**RECORD
DOCUMENTS**

**POND GRADING
PLAN**

C7.4

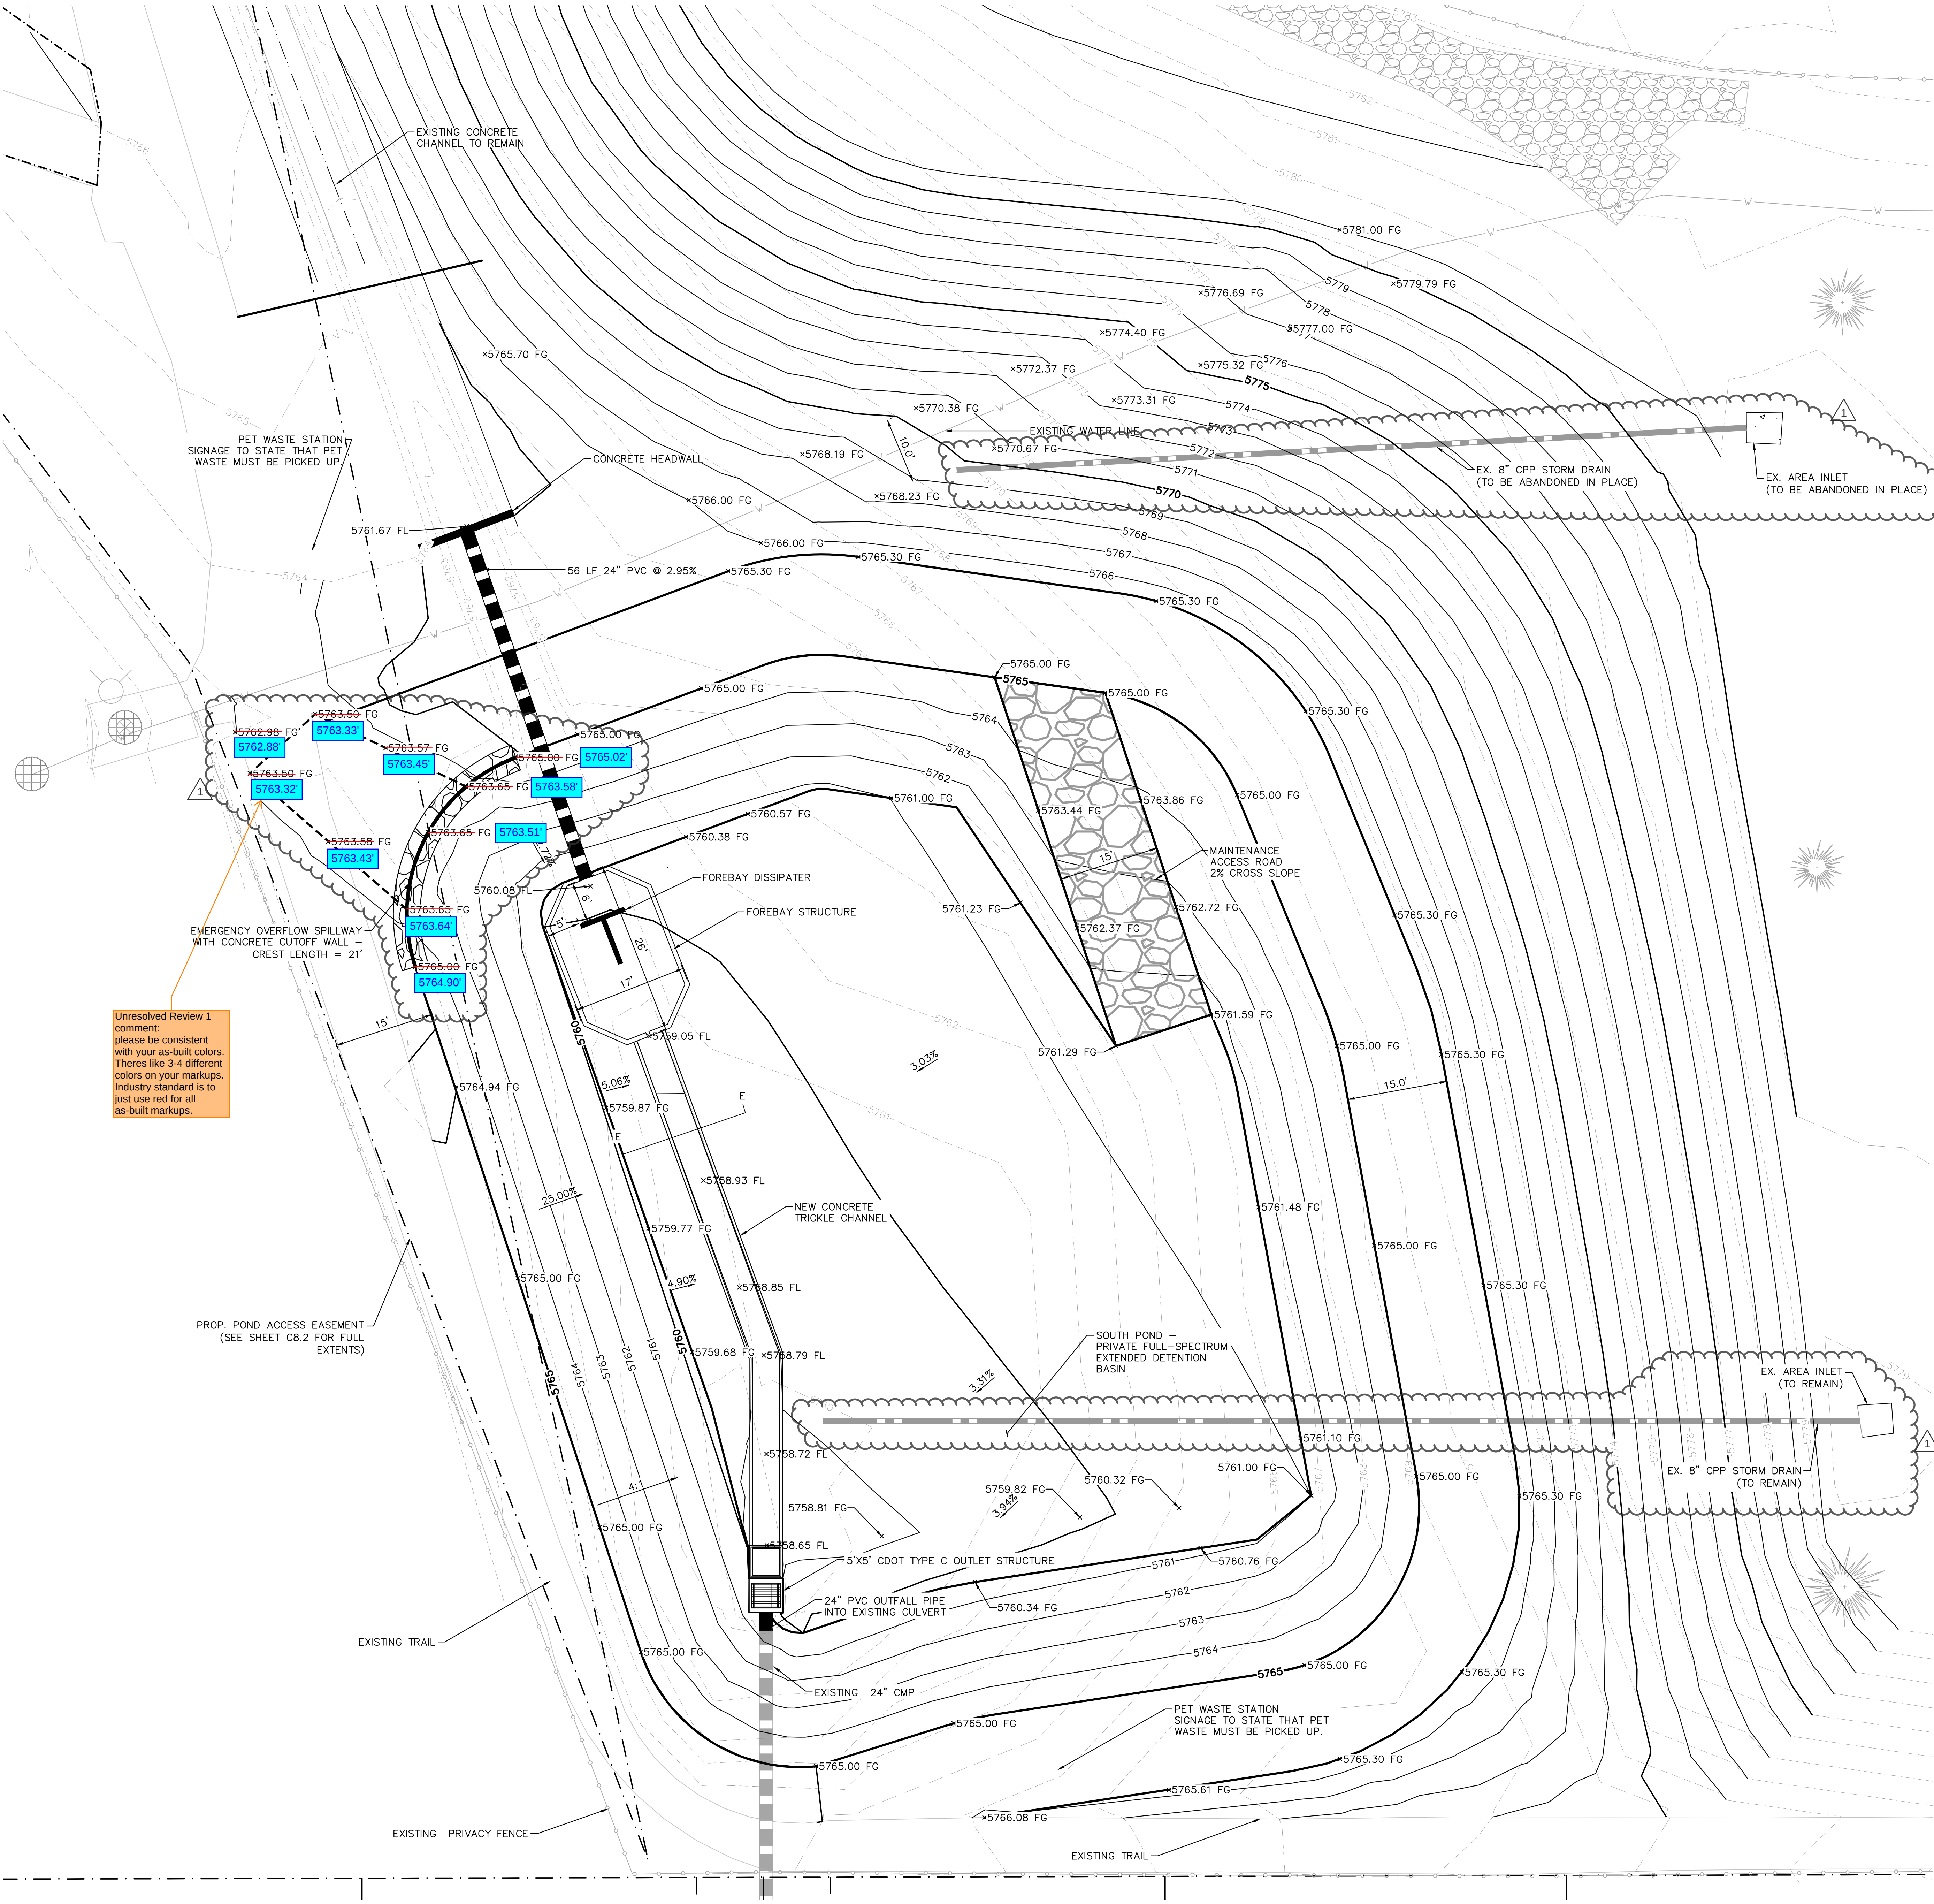
Unresolved Review 1 comment: please be consistent with your as-built colors. There's like 3-4 different colors on your markups. Industry standard is to just use red for all as-built markups.

Per ECM 5.10.6, label each sheet as "As-Built" or "Engineer Record Drawings" with EOR stamp and signature.

Northeast of building. Vegetation has not met requirements. Grading plan shows vegetation in this area but about 1/2 acre of gravel is present. Show on As Builts and update pond calcs or remove gravel and revegetate.

Please discuss with the developer on how they would like to proceed. If they want to remove the gravel and revegetate this area as shown on the approved plans, then no as-built action is needed on your part. But if they would like to leave it as gravel, you will need to look at the runoff and pond calcs and submit them for our review with this ASB project. Include a discussion of your findings/revisions of this research in your Pond Cert Letter (in the case of the developer not wanting to revegetate).

Review 1 unresolved comment: part of the as-built process is redlining items that were not installed per plan, like the microscreen.

Review 2 update: just callout here the make/model of the version that was installed and which you have submitted a spec sheet for.

You should have a callout here that references your multi-colored detail that shows the as-built condition of this. And then add that in as a page to this document.

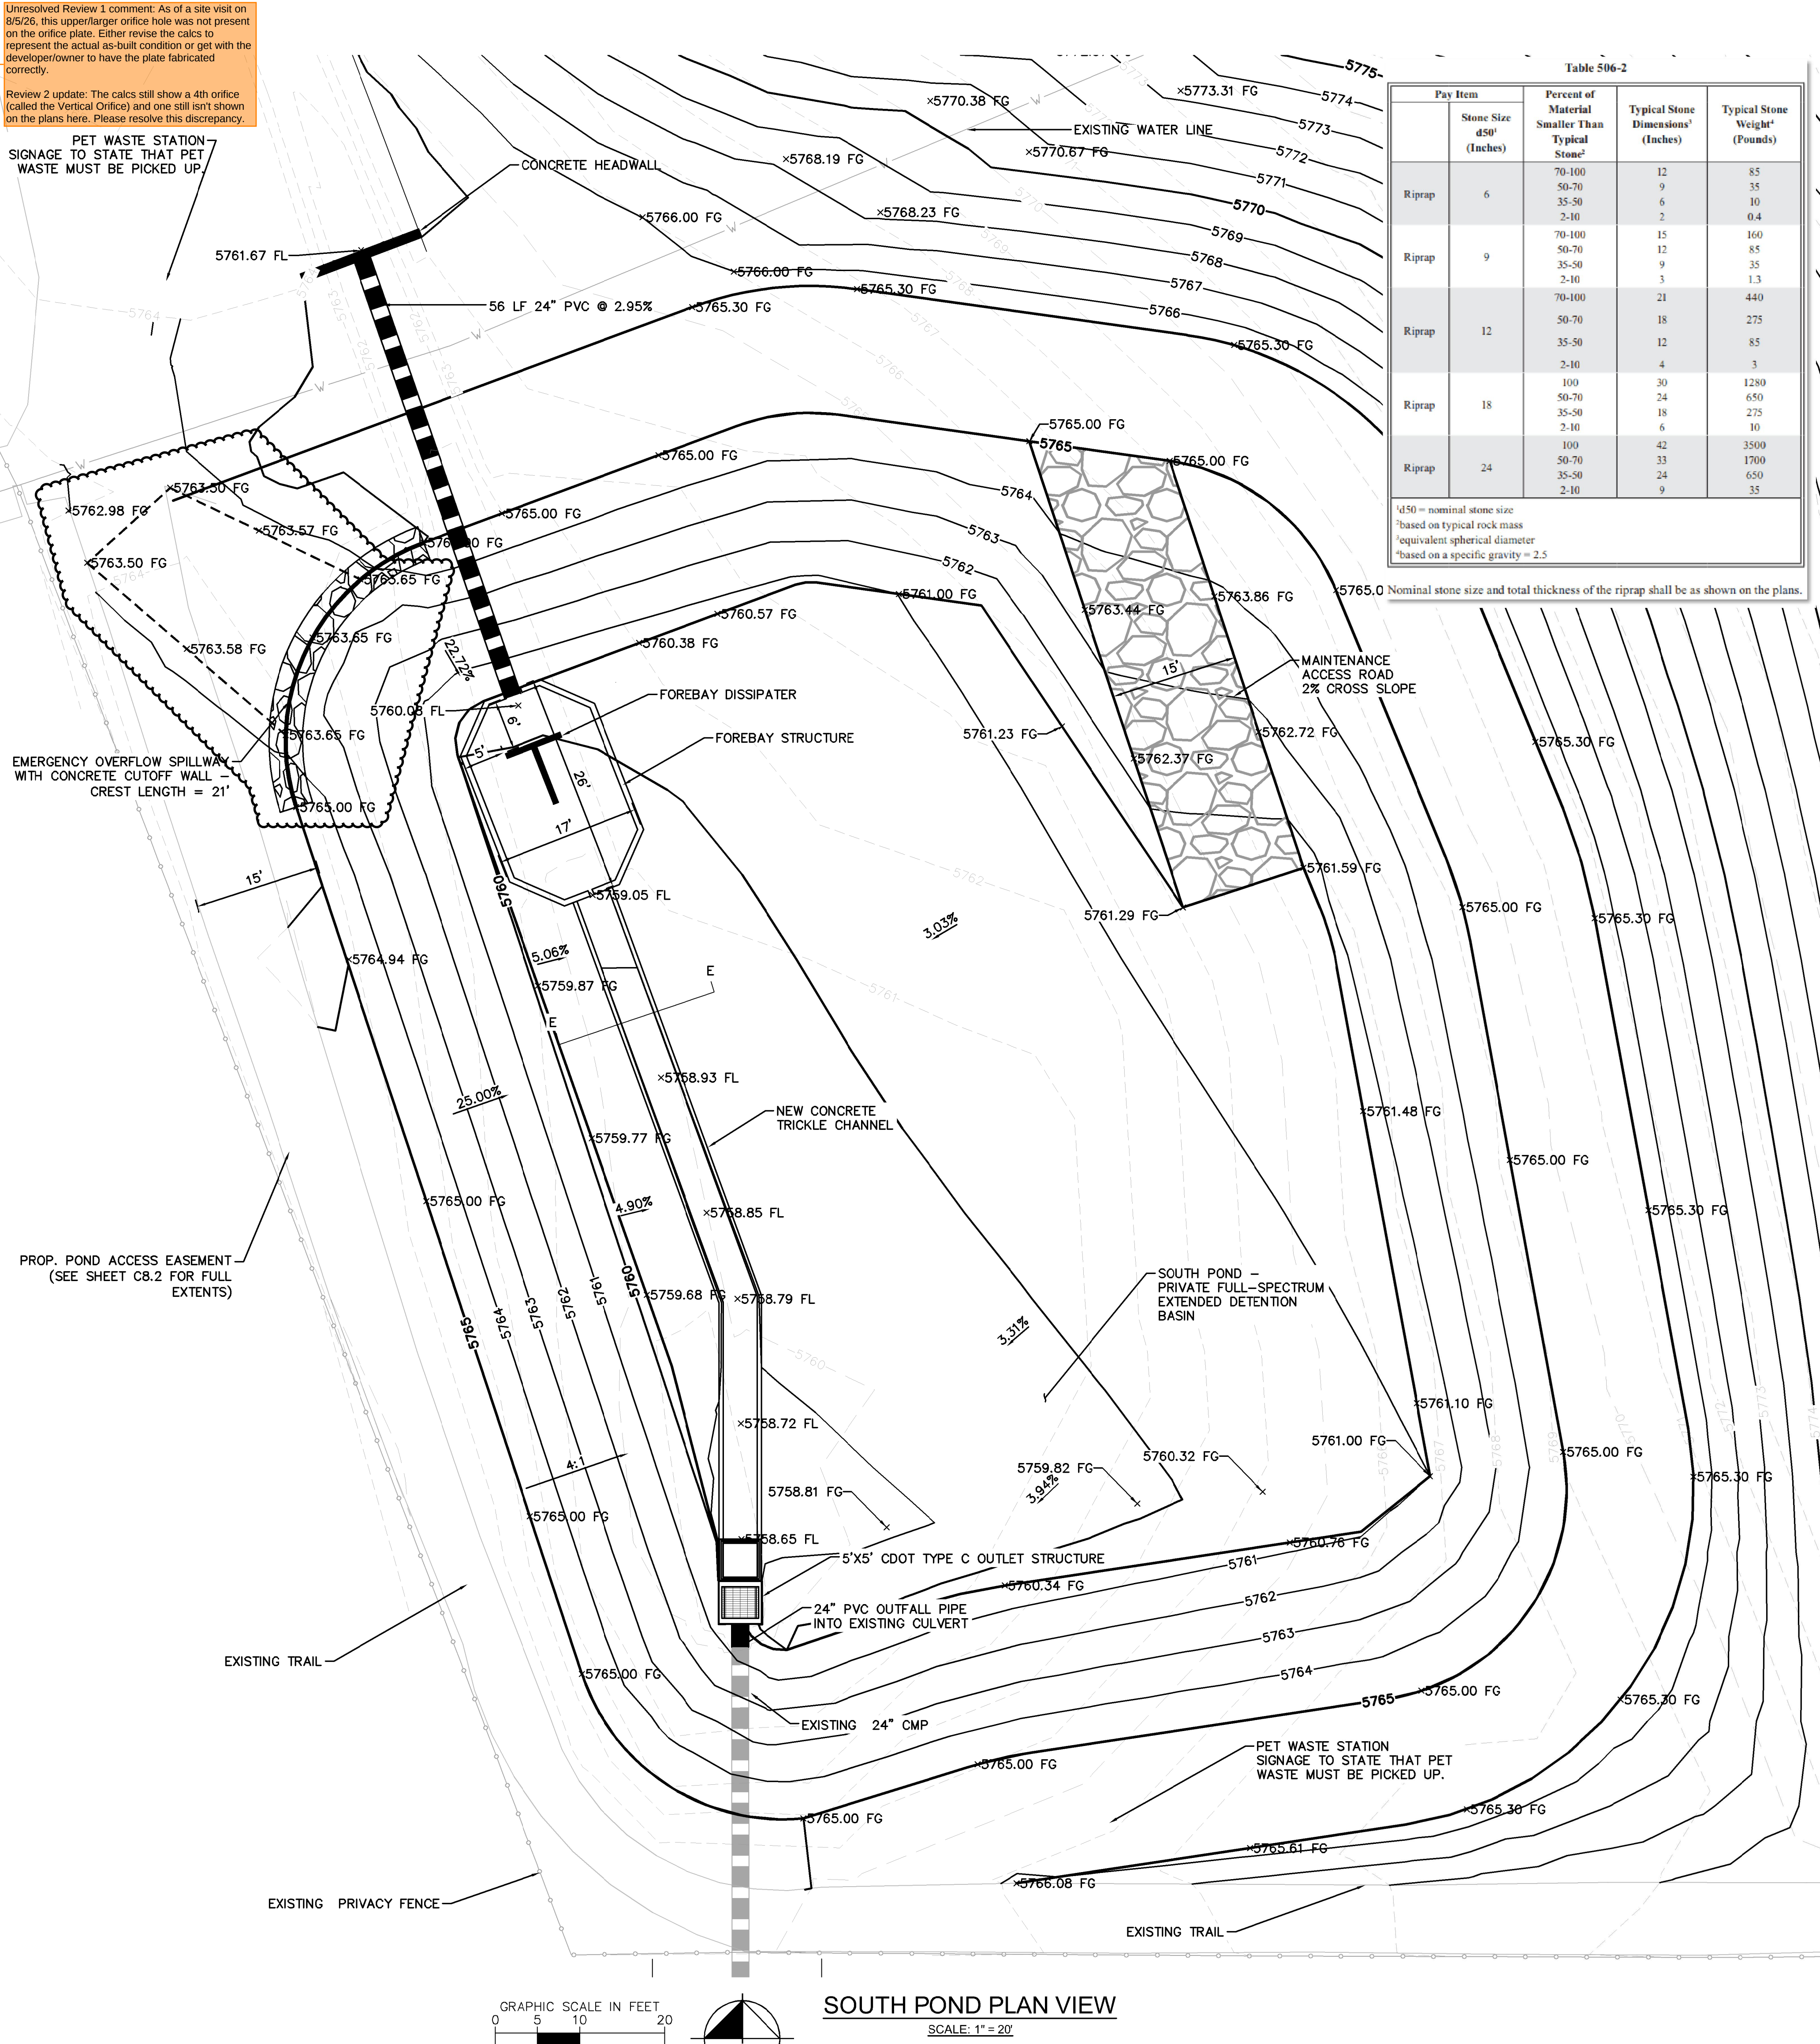
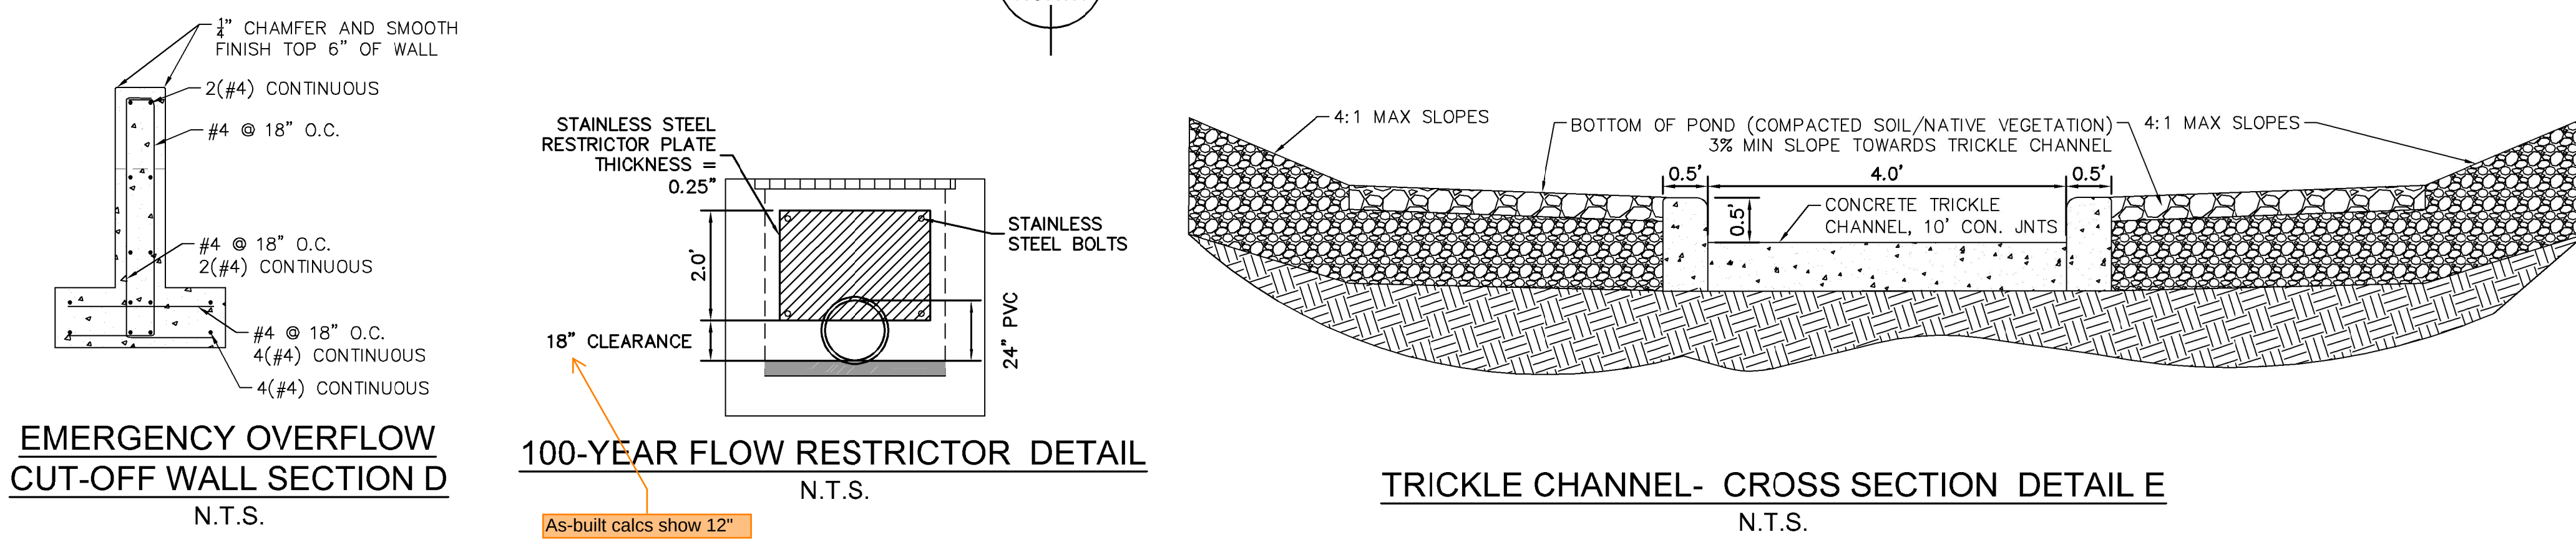
Why is this included? Like your "Crossmember Replacement" doc, this shows instructions for the contractor to do something, it doesn't show the as-built condition. Please revise and/or remove accordingly.

We don't need to see any conversations/notes between you, the contractor, EPC or anyone else. We just need to have you measure, document, and certify the as-built condition of this pond.
